Model : Finisher D1

Ref. No. : FF-T01-W-000049-02

Location : BUFFER ROLLER ASSEMBLY

Subject : CORRECTING ALIGNMENT FAULTS IN THE FINISHER-D1 (DURING WRAPPING ON THE BUFFER ROLLER)

Fig. 2

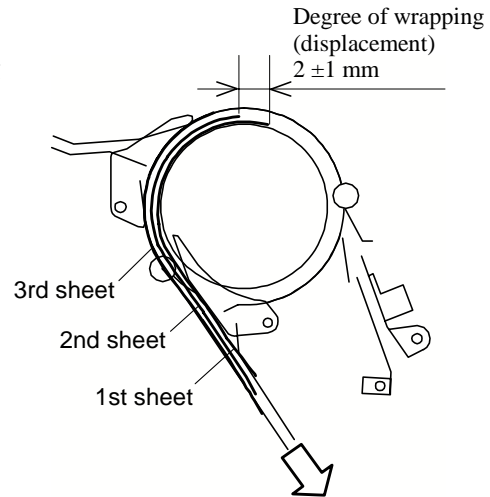
5. Compare the degree (displacement) of wrapping against the standard (2 ± 1 mm; see Figure 2).

Fig. 4

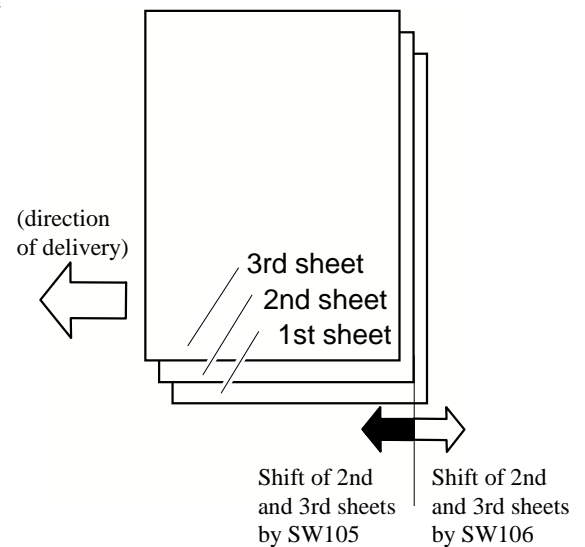
6. Turn off the power, and set the DIP switch (SW103) on the finisher controller PCB as shown in Figure 3.
7. Turn on the power, and press the push switch (SW104) on the finisher controller.
 - LED101 will indicate the present setting.
8. As necessary, press the push switch (SW105 or SW106) on the finisher controller PCB. (See Figure 4.)
 - Each press on SW105 increases the degree of wrapping by 1.74 mm.
 - Each press on SW106 decreases the degree of wrapping by 1.74 mm.
9. Press the push switch (SW104) on the finisher controller PCB.
10. See that the new setting has been stored in memory and LED101 indicates '0'.
11. Turn off the power, and shift all bits of SW103 to OFF.
